# UNITED STATES PATENT AND TRADEMARK OFFICE

APPLICATION NO.	FILING DATE	FIRST NAMED INVENTOR	ATTORNEY DOCKET NO.	CONFIRMATION NO.
09/921,660	08/03/2001	Klaus Heckel	22750/488	8200
26646	7590	06/09/2004	EXAMINER	
KENYON & KENYON ONE BROADWAY NEW YORK, NY 10004			SIMONE, CATHERINE A	
			ART UNIT	PAPER NUMBER
			1772

### **DETAILED ACTION**

4. **Claims 1, 2, 5, 6, 8, 9 and 11-21** are rejected under 35 U.S.C. 103(a) as being unpatentable over Shultz et al. (US 5,670,237) in view of Heckel et al. (5,154,868).

**FIG. 5**

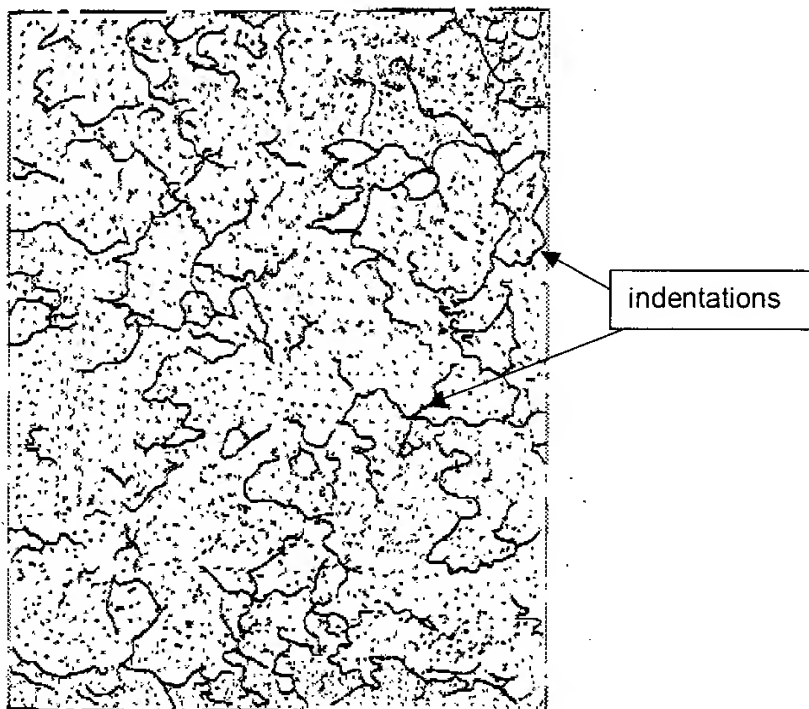
Regarding **claims 5 and 6**, note each indentation intersects at least two other indentations (see Figure 5 shown below). Regarding **claims 8 and 9**, note the indentations have shapes that differ one from the other (see Figure 5 shown below). Regarding **claim 11**, note the surface percentage of the indentations is 5% to 50% of the total surface of the floor covering (see Figure 5 shown below). Regarding **claim 12**, note the surface percentage of the indentations is 20% to 40% of the total surface of the floor covering (see Figure 5 shown below). Regarding **claim 13**, note the indentations have the same depth over their entire length (see col. 6, lines 15-17). Regarding **claim 14**, note the remaining surface of the floor covering is essentially planar (see Figs. 3a-3d). Regarding **claim 15**, note the width of the individual indentations varies (see Fig. 3b). Regarding **claim 16**, note the length of the individual indentations varies (see Fig. 5 shown below). Regarding **claim 18**, note the floor covering is assembled from individual, repeating surface units (see col. 6, lines 26-30). Regarding **claim 19**, note the floor covering is made up of a single-layer material (see col. 5, lines 55-61). Regarding **claims 20 and 21**, note the floor covering has a thickness in the range of 2 mm to 5 mm and in the range of 2.5 mm to 4 mm (see col. 11, lines 31-32).
